ONE-STEP FINAL PLAT
AUBURN HILLS 3RD ADDITION
WICHITA, SEDGWICK COUNTY, KANSAS

Re: S/D 96-83 - AUBURN HILLS 3RD ADDITION (Final Plat)

Re: S/D 96-83 AUBURN HILLS 3RD ADDITION (Final Plat)

CASE NUMBER: S/D 96-83 - AUBURN HILLS 3RD ADDITION

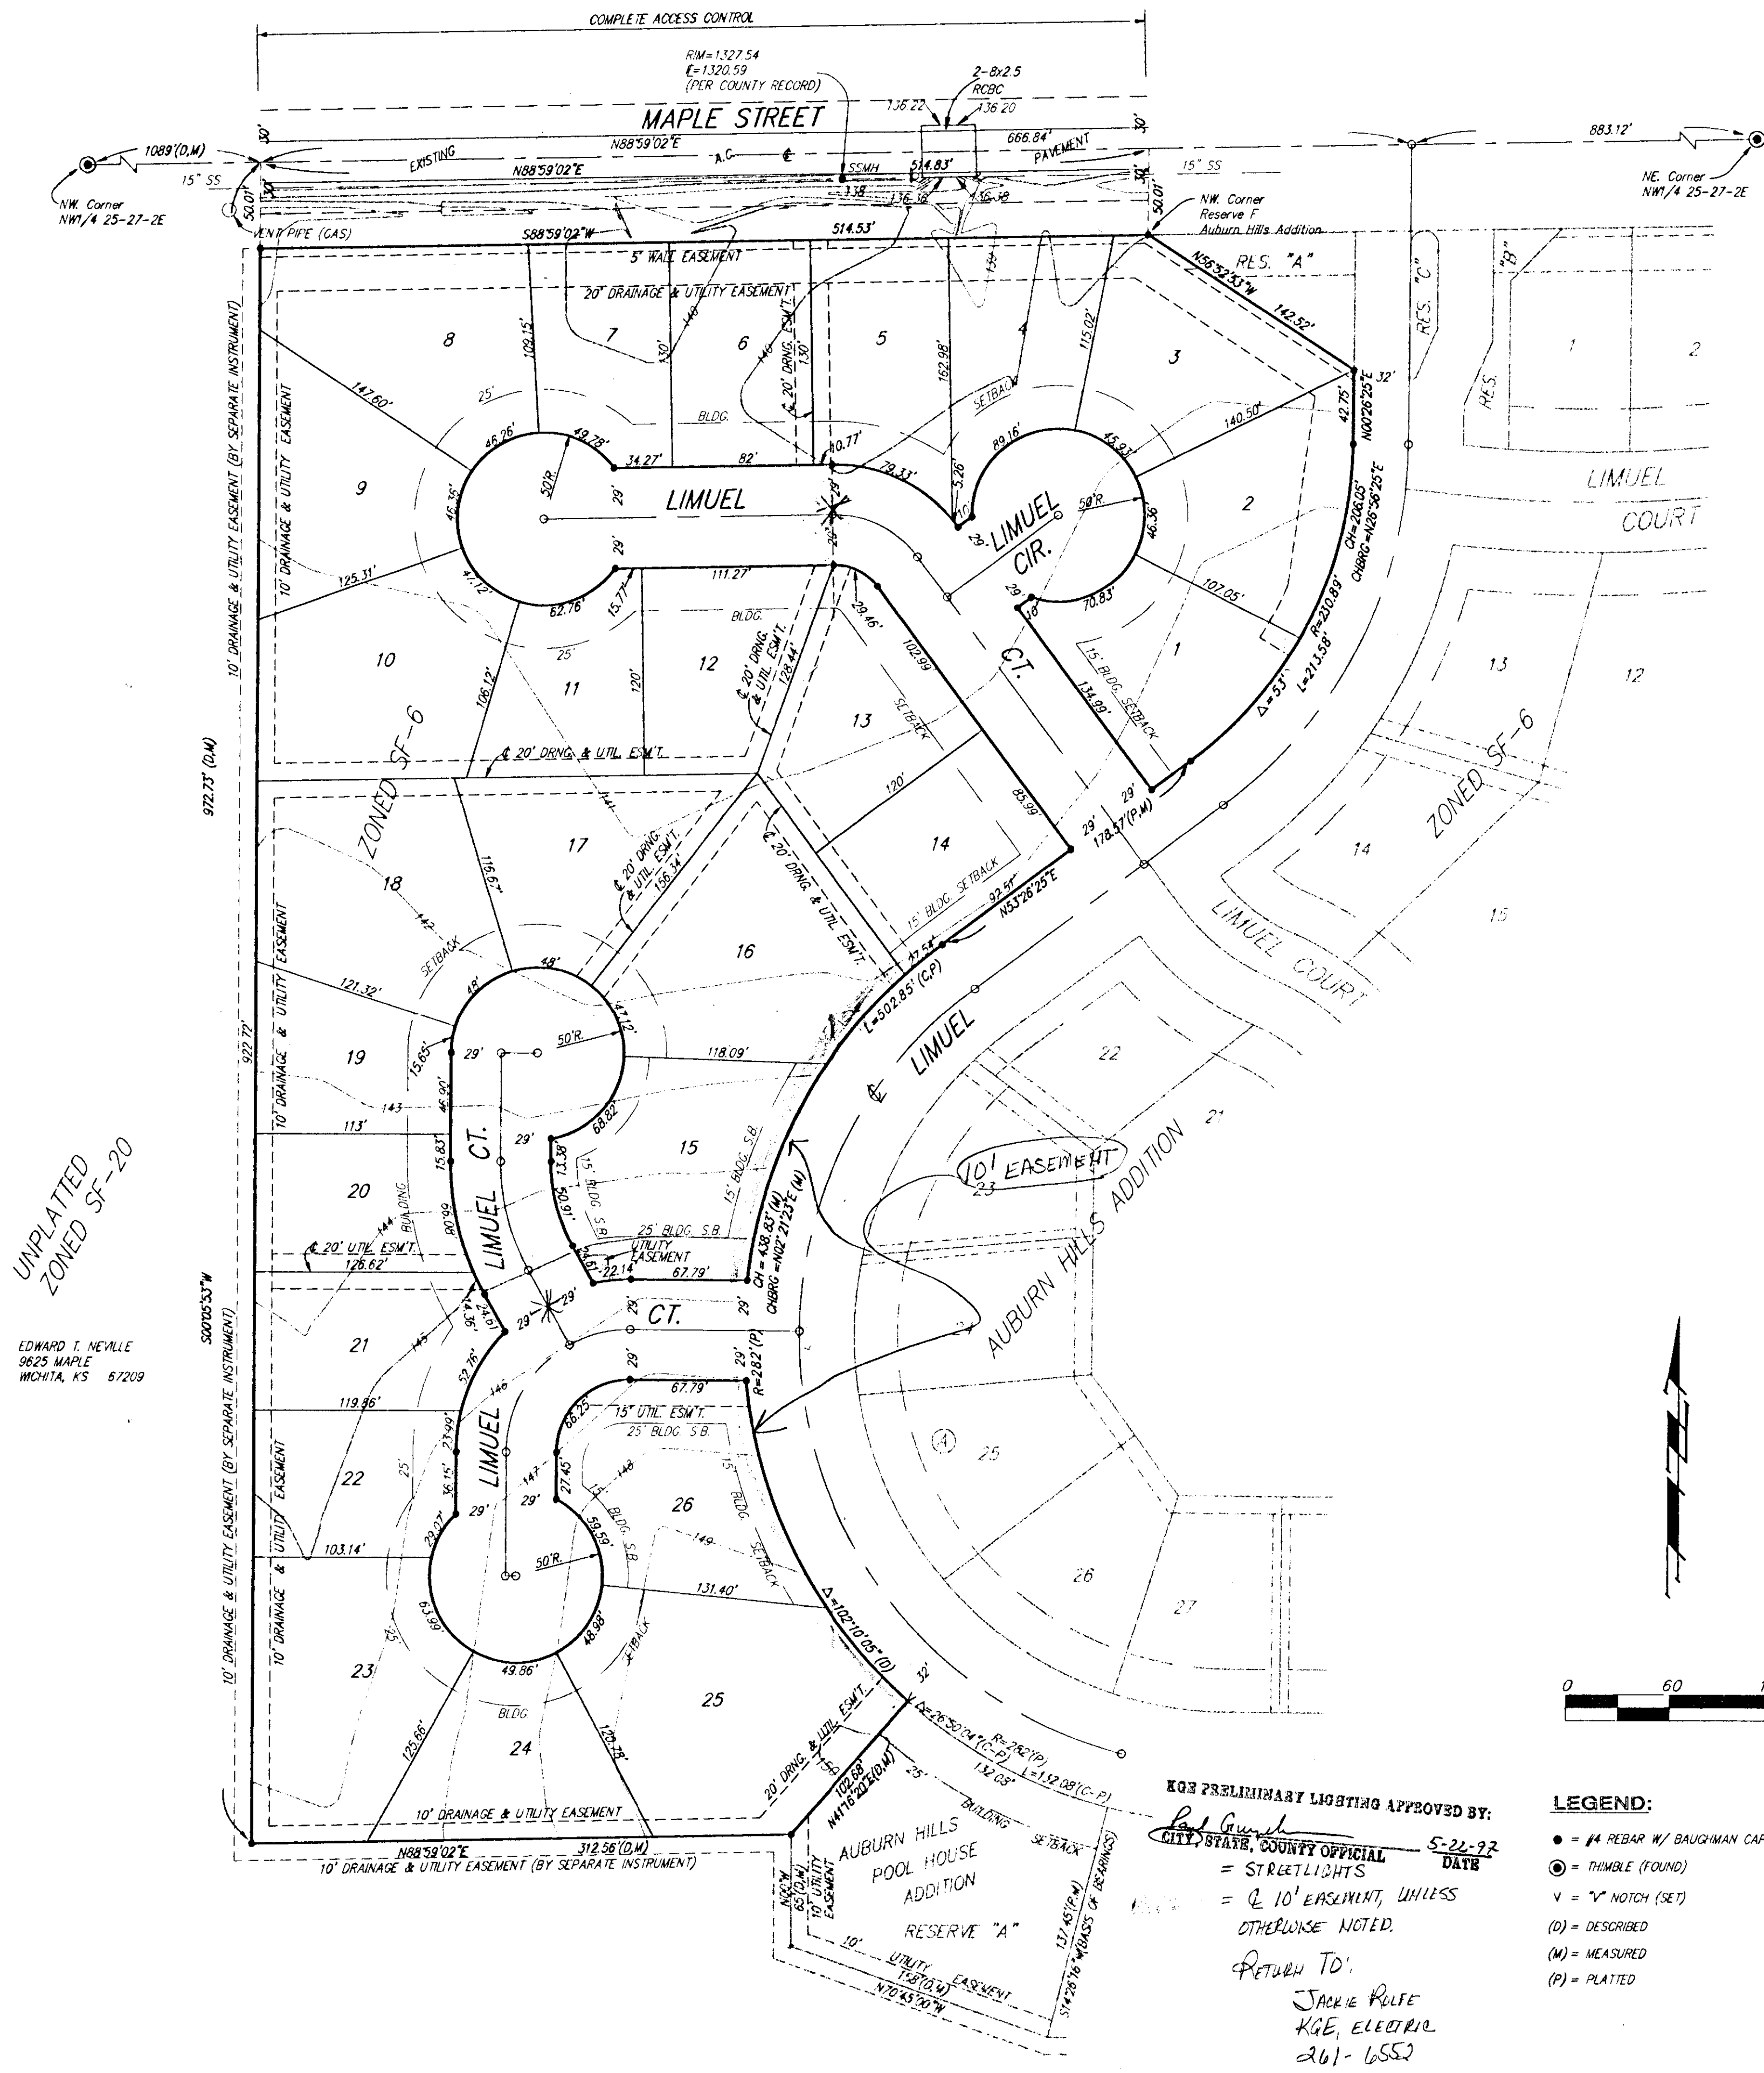
- H. On the final plat tracing, complete access control shall be shown to Maple from all abutting lots.

- R. The final plat tracing shall indicate the utility easements requested by K.G. & E. which are indicated on the enclosed "marked" copy of the plat.
- S. On the Final Plat Tracing, right-of-way for Maple shall be provided for 50-feet of 1/2 street right-of-way from this site. It appears that the 40-feet shown is not accurate and that 50-feet is the actual dimension. In any case, 50-feet shall be dedicated and properly shown.

- T. On the final plat tracing, the center line ("CL") of Maple shall be labeled.
- U. On the final plat tracing, the following amendments shall be made to the platfor's text.

1. The dedication of complete access control to Maple from adjacent lots shall be noted.
 2. The dedication of streets to and for the use of the public shall be acknowledged.

3. The uses anticipated for each Reserve shall be clearly indicated.
 4. The prohibition on fences in all easements appears to be implied. If such fencing is only to be prohibited in the easements involving access, the text shall be amended to limit this restriction specifically to those easements (allowing access). For the other combined utility drainage easements, (not the street-drainage-utility easements) the text shall, however, clarify that fencing within these easements will be allowed.

5. Both the face of the plat and platfor's text has deleted reference to a wall easement along the site's north line. If a wall is still intended, both the face of the plat and platfor's text will need to indicate this. In regard to the 20-foot easement now being shown, any 5-foot wall easement would need to be platted exclusive of any other such easements (utility, drainage, etc.). That is a 20-foot utility/drainage easement, with an adjacent 5 ft. wall easement would need to both be shown.

- V. Since this is a plat of unplatted property, the reference to K.S.A. 12-512(b) in the Surveyor's text is generally not appropriate unless public reservations by separate instruments are involved. However, the platting indicates that no separate instruments are involved on this site.

- W. In regard to W. Kent, the prefix "W" does not appear to be appropriate. Kent exists to the east of this site (1/2 mile) but is only found in this area. That is, there is no "E" side Kent and the use of "W" Kent may imply a new, different Street. The "W" therefore shall be deleted. Also, the "eyebrow" court coming off of Kent as shown is not a circle, and if distinctly named, should be labeled as a Court (a Kent Ct.)

- Y. Also, the plat binder indicates that the State Bank of Colwich holds a mortgage on this site. This party shall therefore be shown on the plat as a signatory.
- Z. On the final plat tracing, "Deputy" shall be deleted from the City Clerk's signature block.
- AA. On the final plat tracing, additional information shall be shown for street right-of-way. Both the width of Limuel Court along the spine of this street and the radius of the turnaround need to be shown.

For Kent, additional street right-of-way dimensions need to be shown for this street's entrance from Limuel and for the Court area that surrounds Reserve "D". If necessary, separate distinct drawings of these areas may need to be added to the final plat tracing.

- BB. On the final plat tracing, the indicated tiepoint to the N.E. corner of the N.W. 1/4 (quarter) needs to reference range 2W not 2E.
- CC. Also, the tying of this site to a Reserve in the Auburn Hills (1st) Addition, at the northeast corner of this plat, should correct the involved Reserve as being Reserve "A" not "F".

- DD. On the final plat tracing, appropriate dimensions shall be shown for the building setbacks of corner lots. Specifically, Lots 20 and 25, Block 1, shall indicate a 15-foot building setback to Limuel. Lot 1, Block 2 also needs to indicate additional dimensions to better describe the setback being shown to Limuel.
